SAUSALITO-MARIN CITY SANITARY DISTRICT

ADDENDUM NO. 1

**Treatment and Wet Weather Flow Upgrade
(Project No. 0055-006)**

January 5, 2017

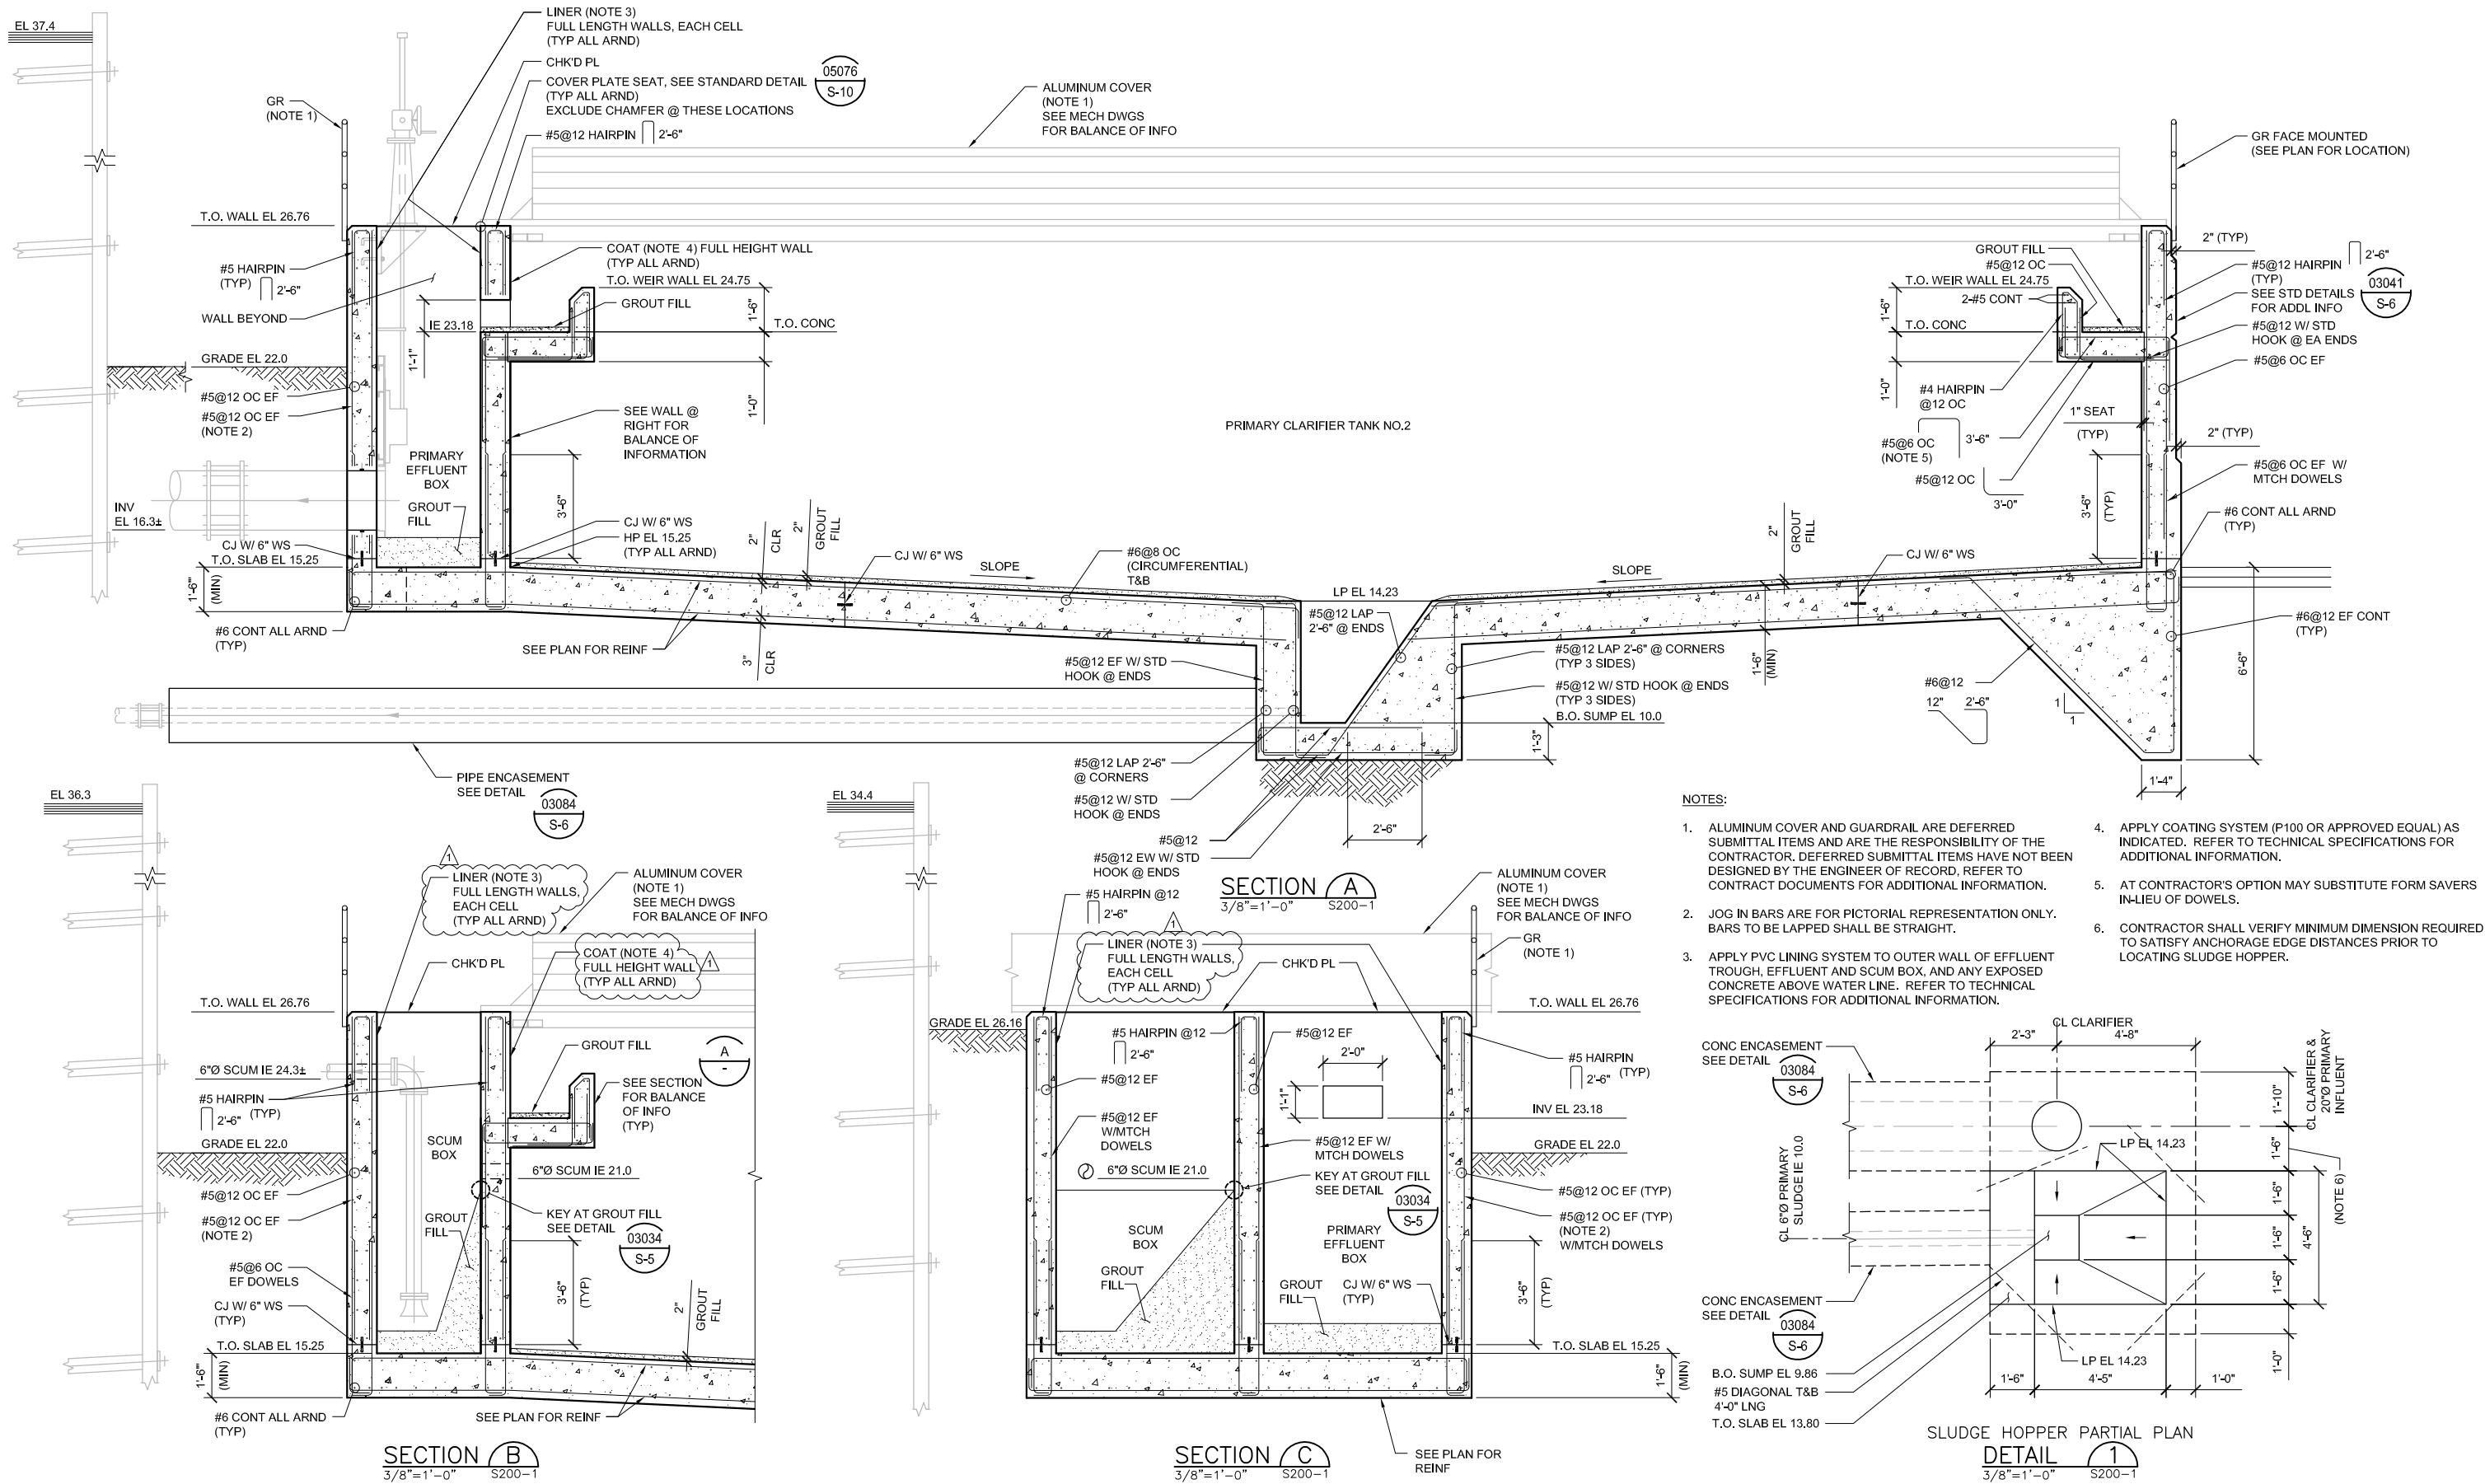
- 1.13 Sheet 109, Dwg. No. S200-2, PRIMARY CLARIFIER NO. 2 SECTIONS AND DETAIL**
Change: Delete Sheet 109, Dwg. No. S200-2 in its entirety and replace with version as provided in Attachment No. 7.

DWG NO	E-10
SHEET NO	174 OF 226
PROJ NO	055-006
DATE	NOVEMBER 2016

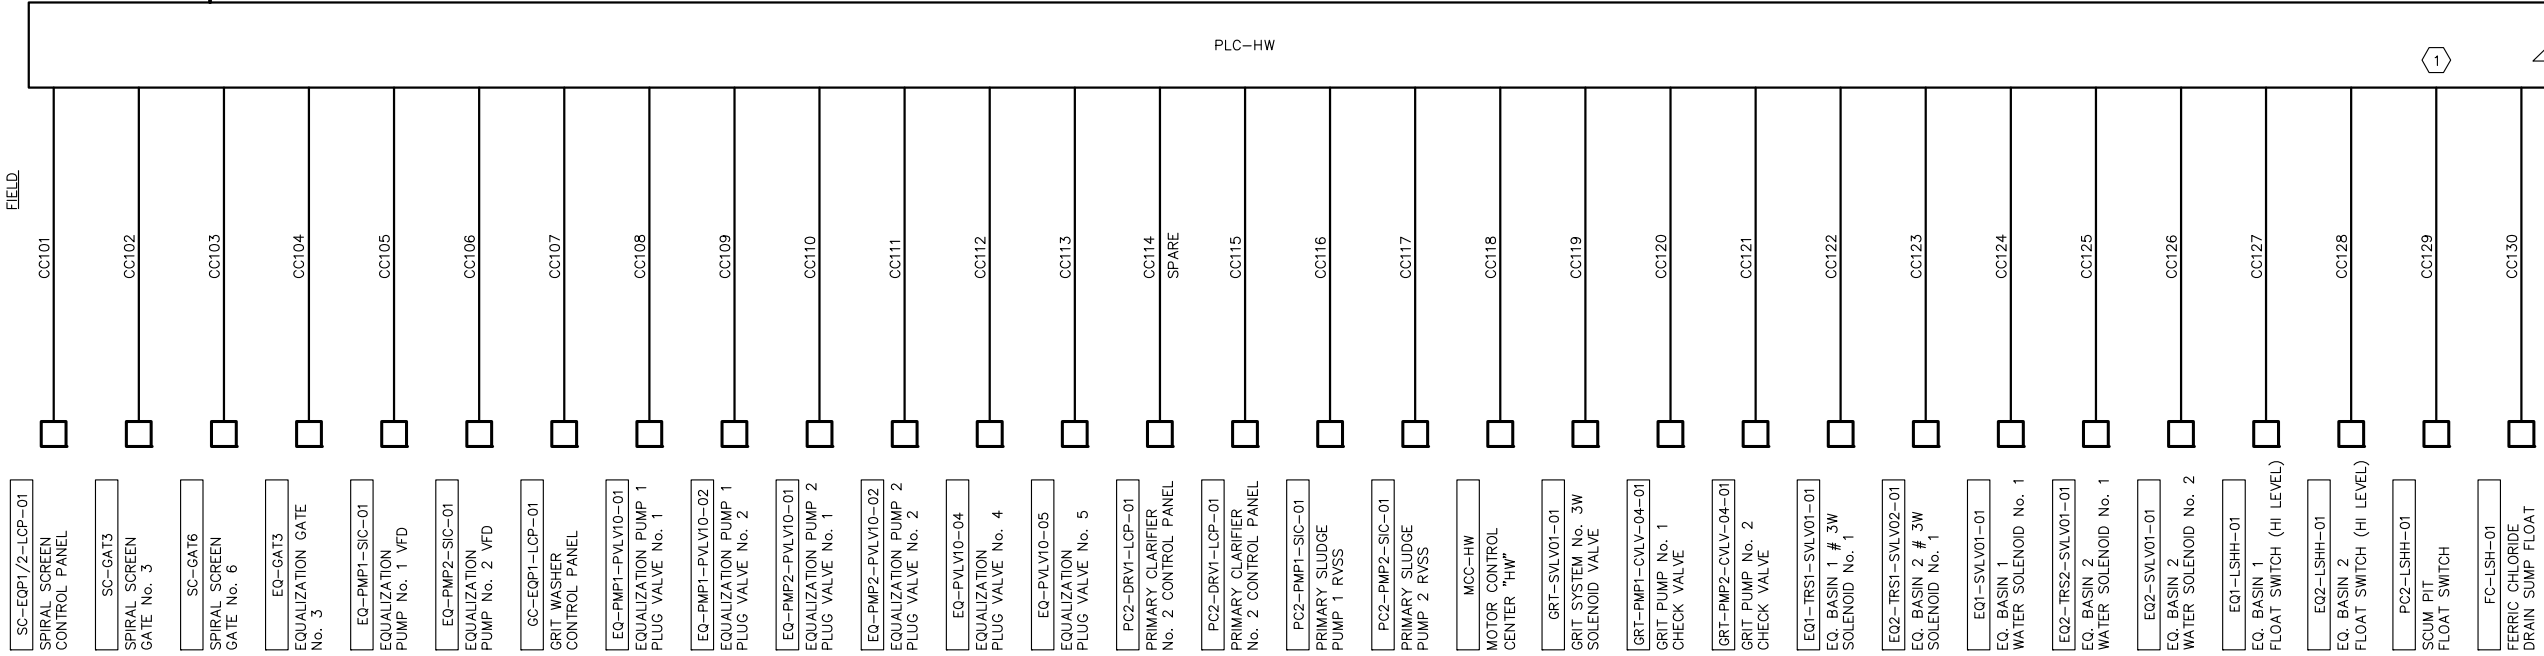
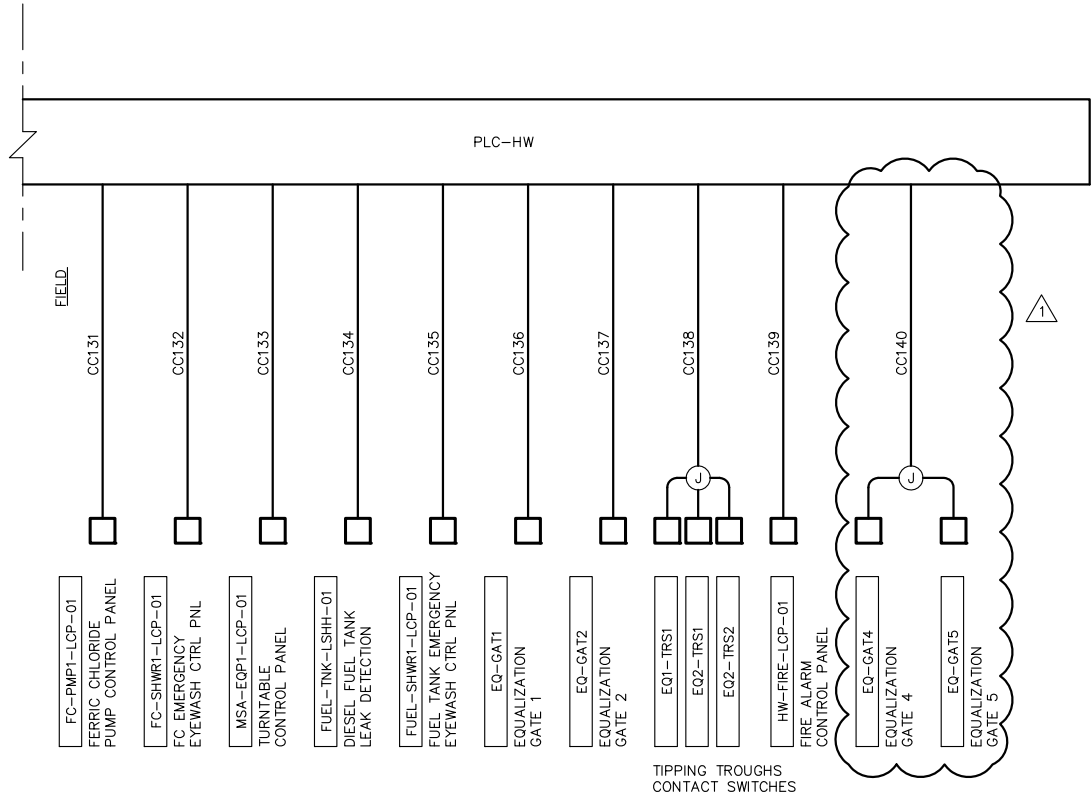
- 1.22 Sheet 174, Dwg. No. E-10 CONTROL ONE-LINE DIAGRAMS, SHEET 1 OF 2**
Change: Delete Sheet 174, Dwg. No. E-10 in its entirety and replace with version as provided in Attachment No. 7.

DWG NO E-13
SHEET NO 177 OF 226
PROJ NO 055-006
DATE NOVEMBER 2016

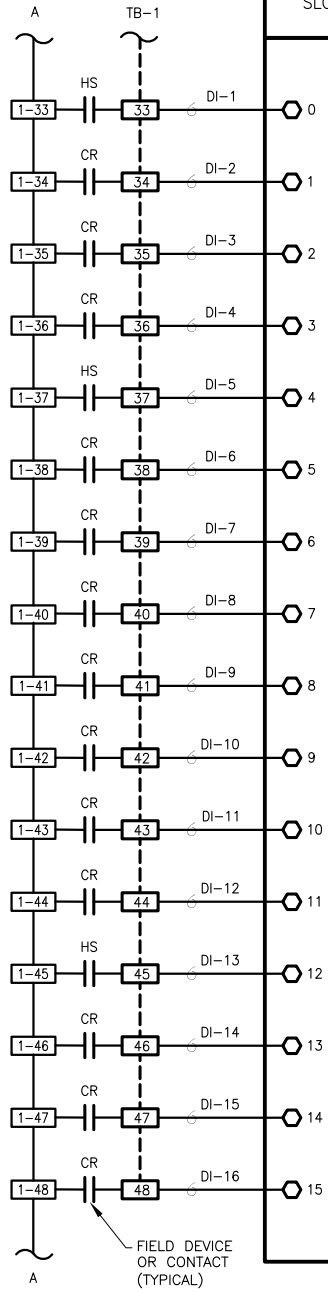
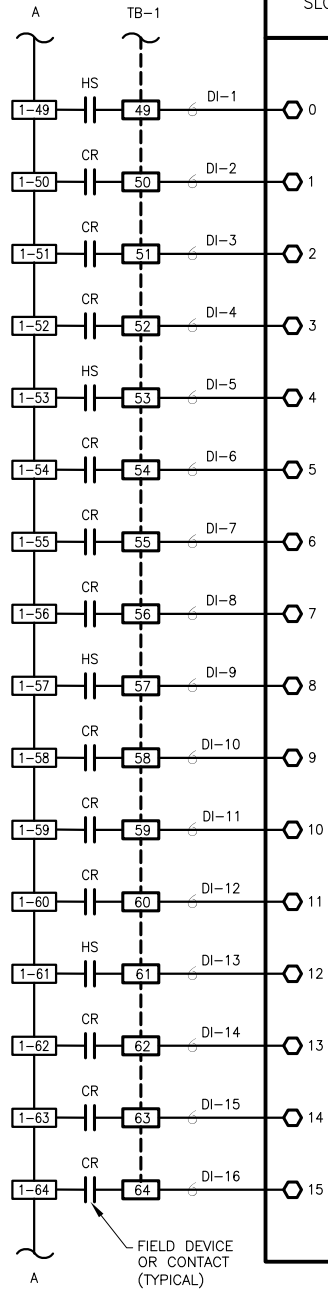
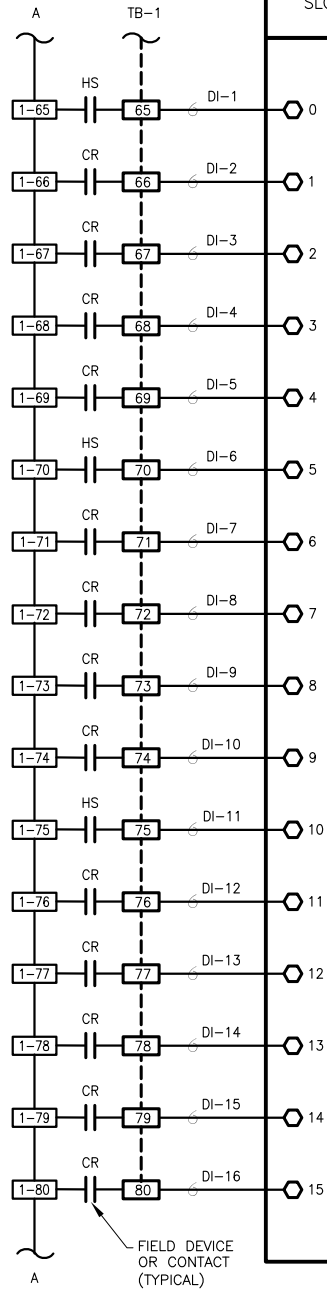
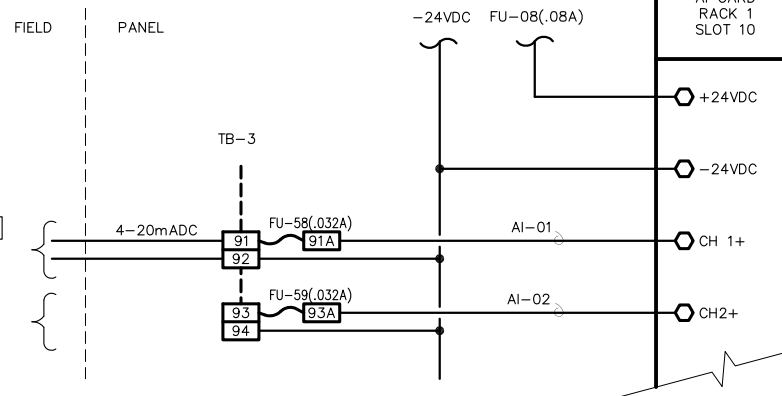
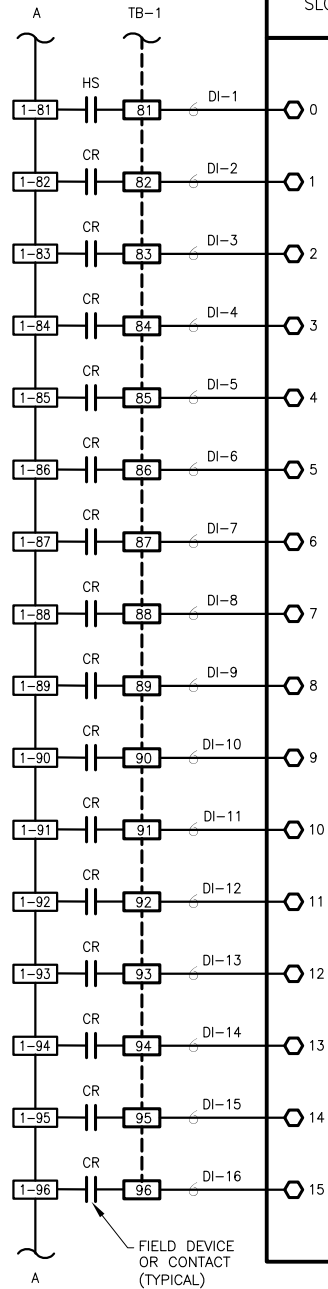
- 1.23 Sheet 177, Dwg. No. E-13 SCADA PLC WIRING DIAGRAMS, PLC-HW-SHEET 2 OF 4**
Change: Delete Sheet 177, Dwg. No. E-13 in its entirety and replace with version as provided in Attachment No. 7.
